PLATTE RIVER RECOVERY IMPLEMENTATION PROGRAM (PRRIP -or- Program) Final Statement – PRRIP Sediment Augmentation Data Synthesis Compilation

The final revised Sediment Augmentation Data Synthesis Compilation is attached as **Exhibit A**. The Peer Review Summary Report, including comments from three (3) Peer Reviewers and a comment/response matrix from the Executive Director's Office (EDO), is attached as **Exhibit B**

PLATTE RIVER RECOVERY IMPLEMENTATION PROGRAM (PRRIP -or- Program)
EXHIBIT A
Final PRRIP Sediment Augmentation Data Synthesis Compilation

December 10, 2024

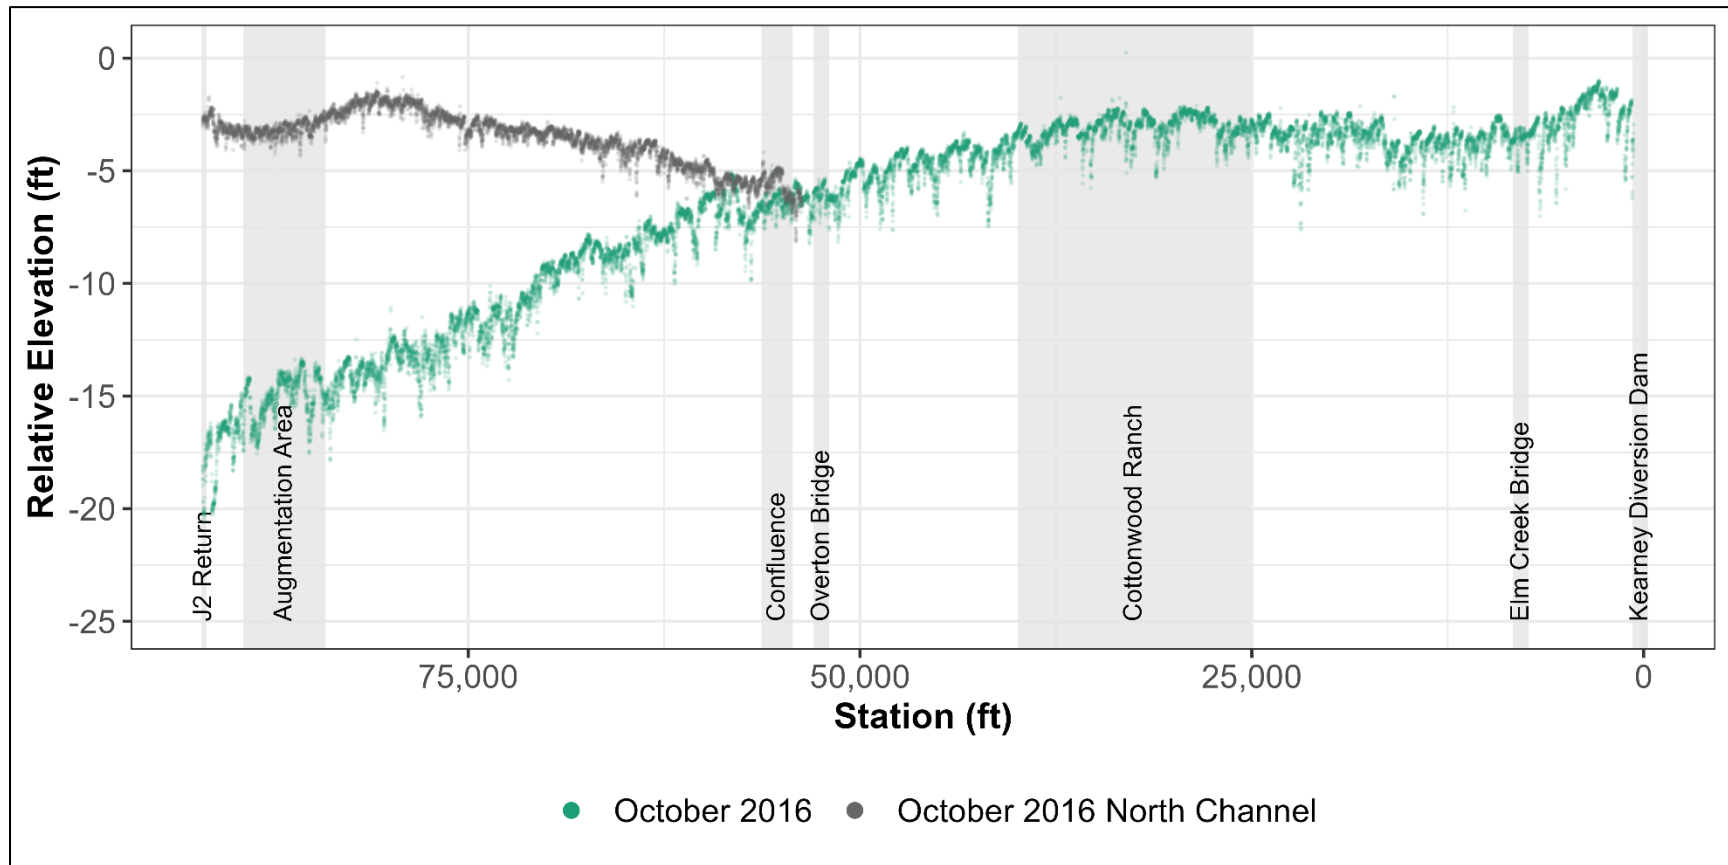
Both thalweg elevation (deepest point in a section) and the mean bed level (averaged over the active channel) are compared to this regional sloping datum. Figure 2.6 shows thalweg elevations relative to the GGL and is a visually compelling summary diagram that captures succinctly the state of the system in 2016. It is an exemplar communication tool. This approach is then extended by integrating thalweg elevations from cross-section survey data in 1989 and 2002, enabling a deeper perspective on the progression of incision over a >25 year period.

Figure 3.5. Annual thalweg alignments (2016–2021) derived from flow accumulation rasters. In the top panel, the transition from wandering to braided planform is present midway through the J2 Return Channel.

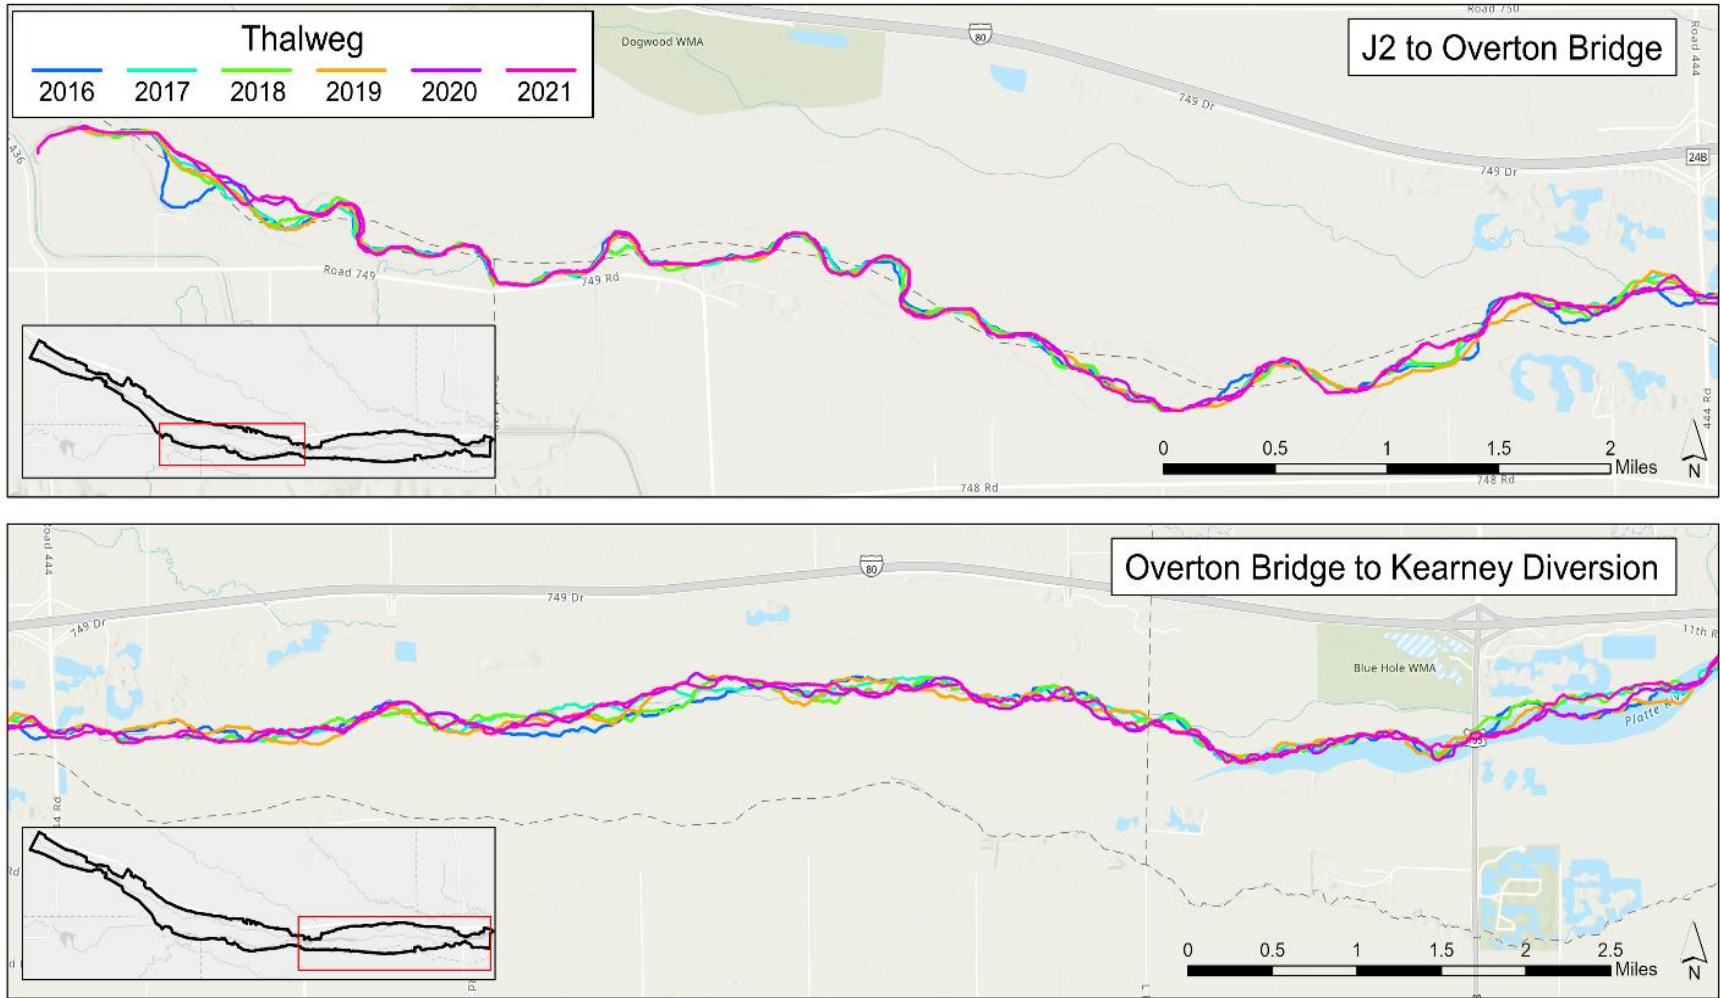
- 6.2 Figure 3.5 is too small – enhance this plot by presenting as a single page.
- 6.3 The caption of Figure 3.16 is disconnected from the figure itself (page 72/73).

Figure 3.18. Planview of thalweg alignments in 2016 (green) and 2021 (orange) between station 74,000 and 55,000.

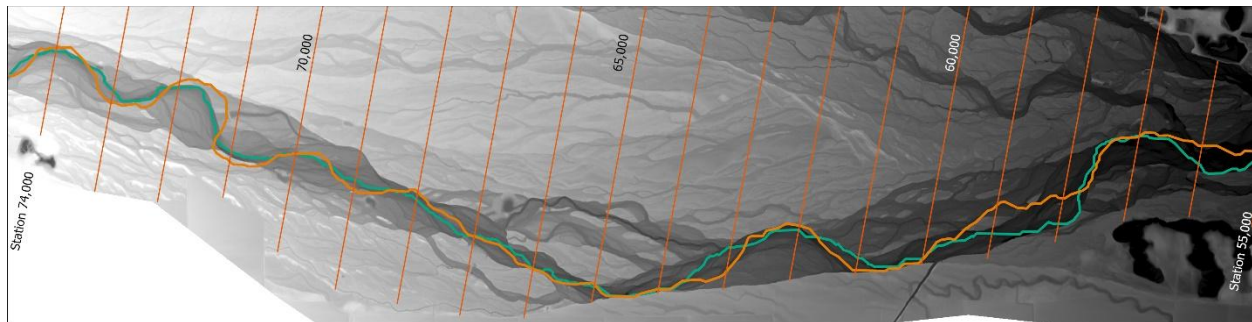
- 6.4 It would be useful to plot the timeseries of thalweg alignments around station 70,000 as an accompaniment to Figure 3.18.
- 6.5 The discharge at the time of capture for the aerial imagery shown for 2016 and 2021 in Figure 3.2 clearly differs. I would be useful to back out the discharge for the two acquisition dates and add this to the images as a label or as a note in the caption
